| Project | IEEE 802.16 Broadband Wireless Access Working Group < http://ieee802.org/16 > | |
| Title | A method of shortening the duration of scanning neighbor BSs | |
| Re: | IEEE 802.16e D4 Draft | |
| Purpose | To incorporate the changes here proposed into the 802.16e D4 draft. | |

Figure E.5 – Example of periodic scanning during HO process with using the method of shortening scanning time

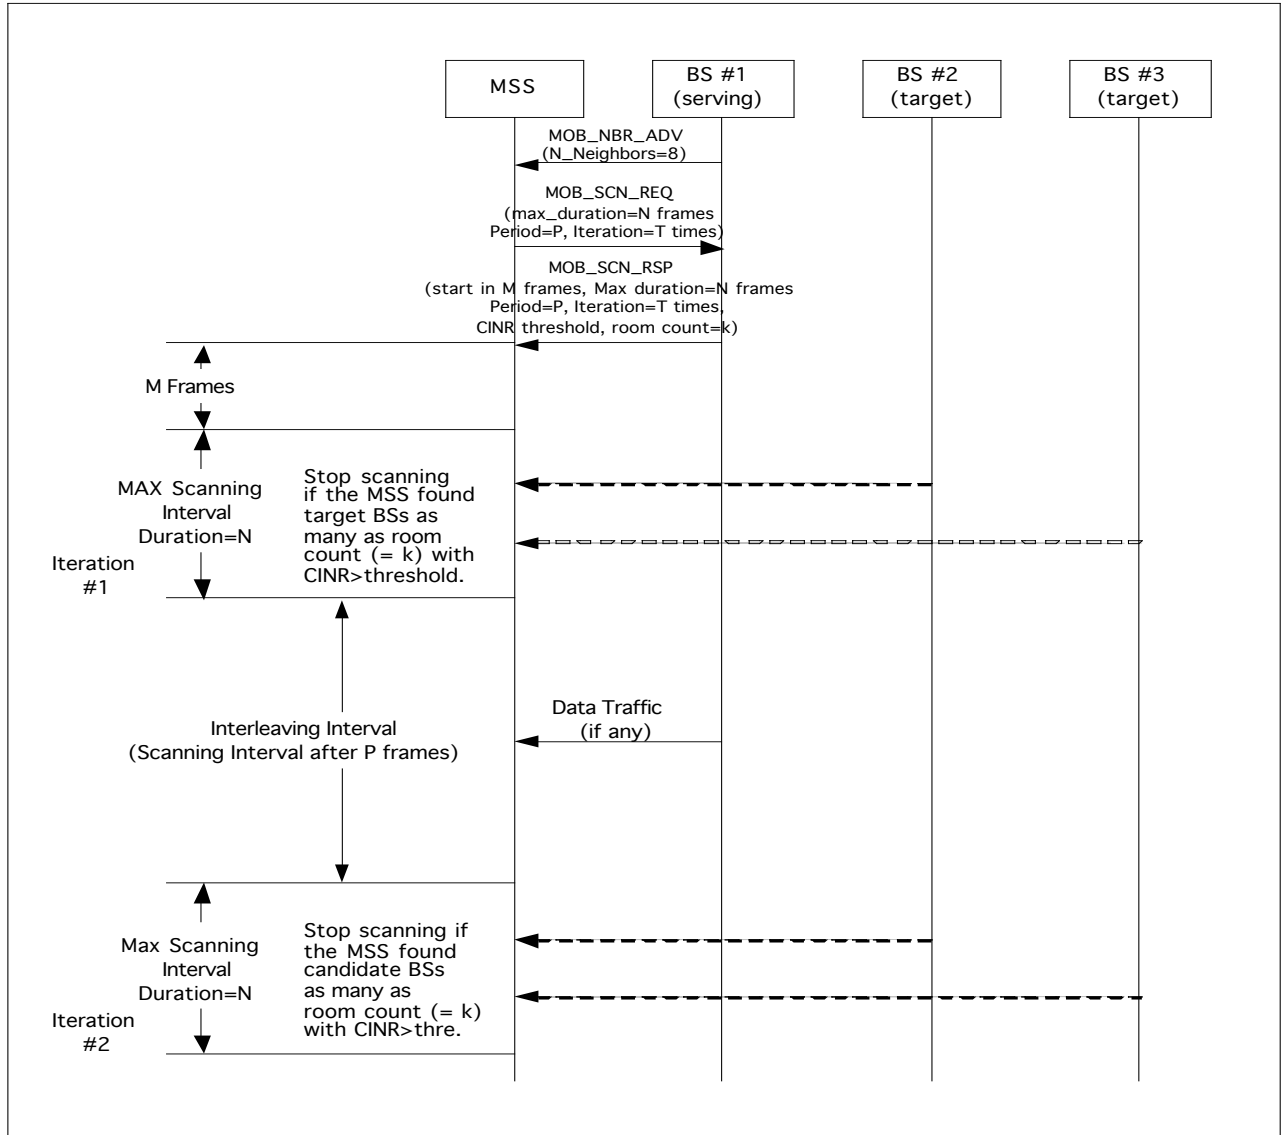
The following figures describes the messages flow for neighbors advertisement and scanning of neighbors by the MSS request, BS request and periodic scanning of neighbors during hand-over with the using the method of shortening duration of scanning time.

Figure E.1—Example BS advertisement and scanning (without association) by MSS request

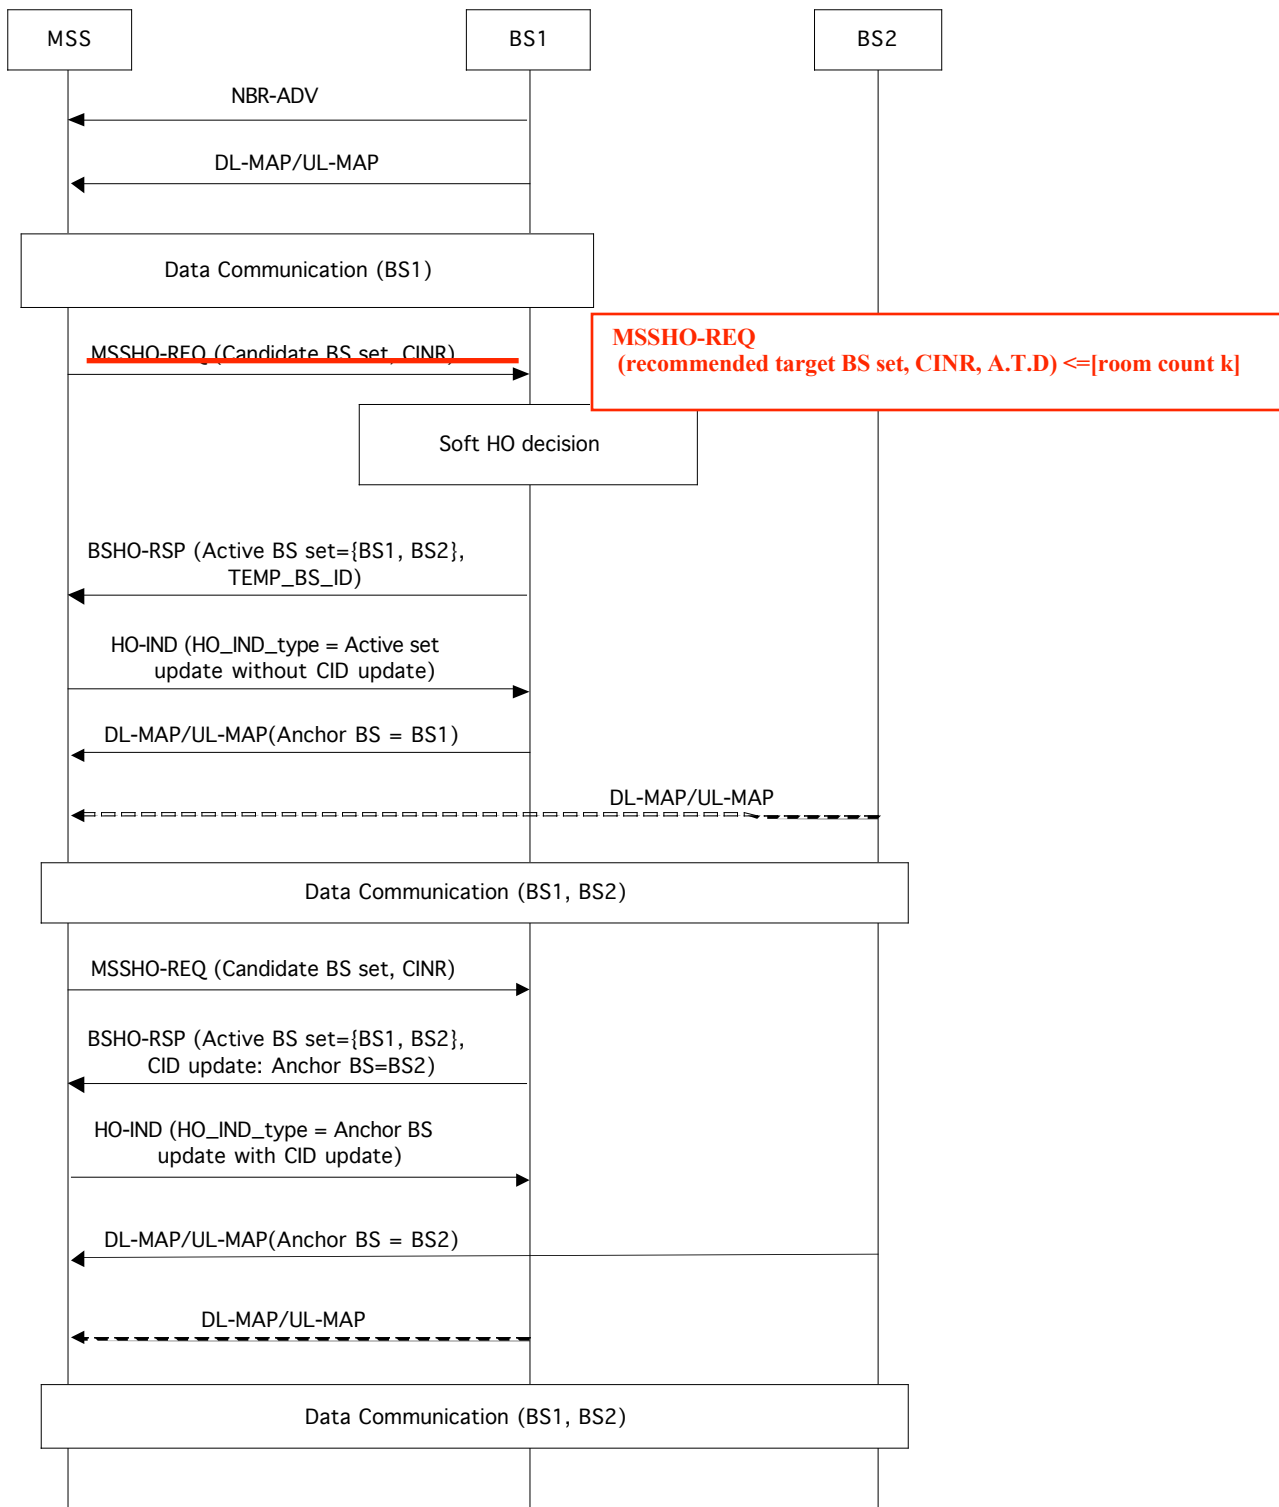
[Modify the Figure E.1– Example BS advertisement and scanning (without association) by MSS request]
